**From:** Andrew Currin  
**Sent:** Tuesday, August 18, 2020 9:07 AM  
**To:** 'Misty Lyons'; maggiemay020283@gmail.com  
**Subject:** RE: Lot 4 Ashe Ave  
**Attachments:** Requirements for Submittals of Soil Reports and Pretreatment Systems.pdf

Owner: ASHE TRAIL  
 Address: LOT 4  
 Location: ASHE AVENUE

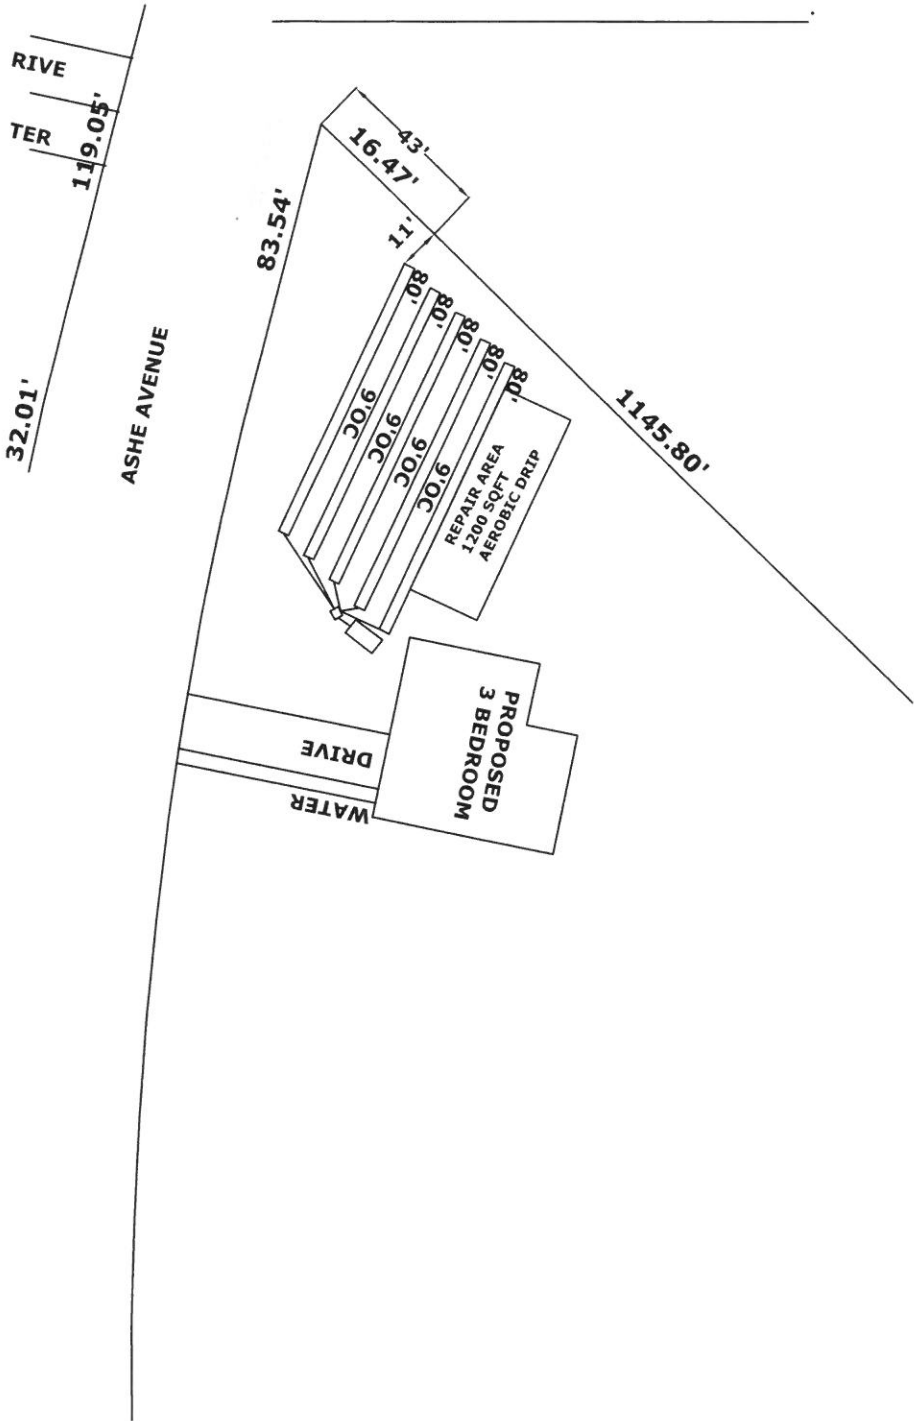
In consultation with our office the report you filed and existing markings on the property do not allow for approval at this time.

- 1) The Soil Report sent over is for an Engineered Option Permit (EOP) originally documented by Pittman Soil Consulting. Due to the advanced system (TS-II Pretreatment) repair, a detailed proposal must be provided by a Licensed Soil Scientist (LSS). Additionally, due to the tight and shallow nature, an onsite layout of initial and repair is required. The lot cannot be approved without a detailed proposal and onsite layout. Attached you will find guidance of the requirements for submittal for the Licensed Soil Scientist (LSS).
- 2) Surveyed Property Irons shall be exposed and clearly visible. Surveyed property lines shall be clearly marked in vicinity of home site (left side, front).
- 3) Revised SWMH location – Per the proposed soil report, the SWMH will need to be relocated and site plan revised to be out of whatever septic layout is proposed by your Licensed Soil Scientist (LSS).

Note: The rough layout proposed by the Soil Scientist is for a gravity system. Due to landscape position, gravity requirements, and size of system I would factor in the initial system being a pump system but I will let the Soil Scientist propose.
